THE CITY OF SAN DIEGO

# ENVIRONMENTAL IMPACT REPORT

Project No. 586670  
SCH No. 2018041032

**SUBJECT: THE JUNIPERS:** The City of San Diego has prepared an Environmental Impact Report to evaluate the effects of the Junipers project. The project includes a Site Development Permit, Planned Development Permit, General Plan Amendment, Community Plan Amendment, CIPOZ, Rezone, Vesting Tentative Map, Sewer Easement Vacation and Variance from the Inclusionary Housing Regulations to develop 536 residential units on a vacant 112.3-acre property adjacent to 14455 Peñasquitos Drive. The project entails the development of a vacant property (non-operational golf course) to create a residential subdivision with 455 multi-family attached and detached residences for those aged 55 and above, a three-story building with 81 senior affordable multi-family apartments, a 2.87-acre (net) public park, privately owned/publicly accessible 2.75-mile "Social Loop" trail, 0.52-acre privately owned/publicly accessible park with mobility amenities, other private open space/parks and recreational amenities for project residents' use, and internal streets. Retaining walls around the site perimeter would vary fr

Figure 1

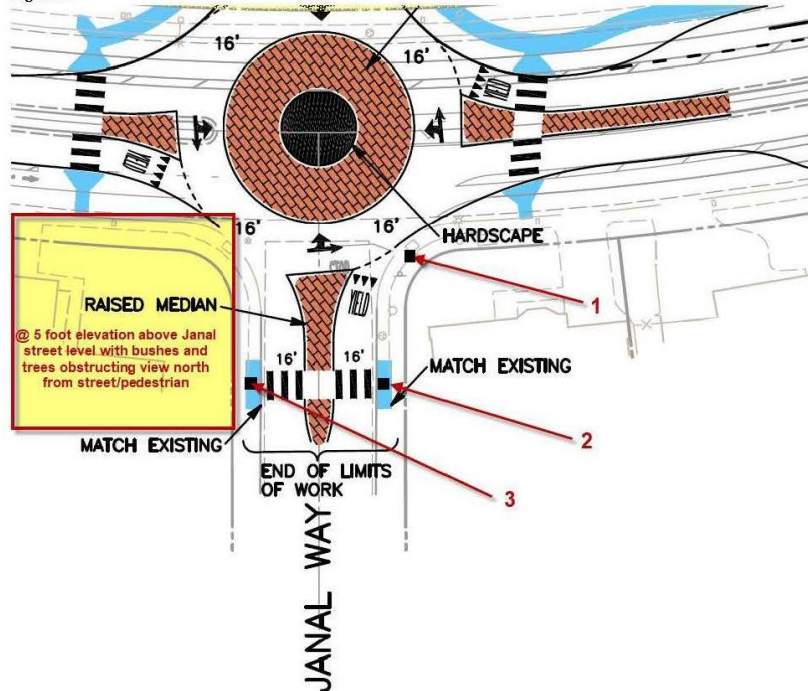
I have several safety concerns with the proposed traffic circle at Janal Way and Penasquitos Drive. Below is part of an image (Figure 1) copied from the draft EIR Appendix B page 62, Figure 15-2A. A few additional notes have been added to clarify the comments and images described in this document. The area outlined in red and highlighted in yellow is part of the property of a home on the north-west corner of Janal Way and Penasquitos Drive. This property is sloped and has a significant elevation difference above the level of the adjacent street, Janal Way. The soil level of this property is approximately 5 feet over the street level of Janal Way and there is also brush and trees on the property. The geographical difference and vegetation obstruct the view from Janal Way to the southern approach of vehicular traffic on Penasquitos Drive. This poses a safety hazard for pedestrian, vehicle and bicycled traffic on Janal Way.

Picture 1 was taken from the existing crosswalk at the southwest corner of Janal Way and Penasquitos Drive indicated by red "1" on figure 1. The view is to the north, across the Janal Way crosswalk with a clear view of the southbound lane of Penasquitos Drive which has a posted speed limit of 35mph.

Picture 2 was taken from the approximate location of the proposed crosswalk indicated by the red "2" on Figure 1. The view is to the north and the visibility of southbound traffic on Penasquitos Drive is clearly obstructed by the hillside geography and vegetation. This poses a safety hazard to pedestrians crossing north across the Janal Way crosswalk, as they are unable to determine traffic flow and estimate a safe crossing time to avoid getting hit by a southbound vehicle turning right from Penasquitos Drive.

A pedestrian standing at the crosswalk indicated by the red "3" in Figure 1 would have zero visibility to southbound traffic on Penasquitos Drive. Picture 3 was taken from this spot looking north toward Penasquitos Drive. A pedestrian attempting to cross southbound on the Janal Way crosswalk would be in grave danger of being hit by a right turning vehicle from Penasquitos Drive as they cannot see vehicular traffic until it has entered the traffic circle.

SI21C-4 As shown on the roundabout plan view in the comment letter and Figure 3-12e of the EIR, the realignment of the intersection with the roundabout would pull traffic movement southerly and extend new sidewalk into area currently shown on the above-cited photographs as vehicular travel way, increasing sight distance and intersection safety.

SI21C-6 As stated and depicted in the comment, the US Department of Transportation (USDOT) has published roundabout standards that specifically include sight distance standards. The proposed project roundabout design meets those sight distance standards. Information and guidance is also provided in the City March 2017 Street Design Manual. Please refer to Figures 3-12Ce and f of the EIR which provide plan and cross section views of the intersection. Figure 3-12e depicts in plain view both existing lane configuration and the proposed configuration. As shown, the crossing locations have been moved north and south, respectively, from Janal Way.

#### Existing Condition:

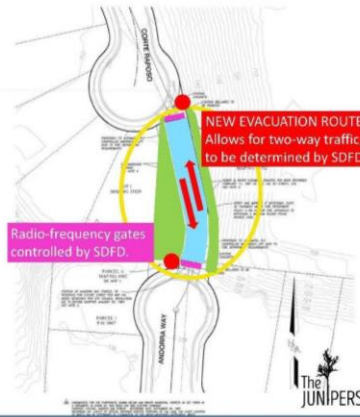
- Bollards currently concreted in place.
- No brush management
- Unsure whether road can support fire engine (50k lb.)
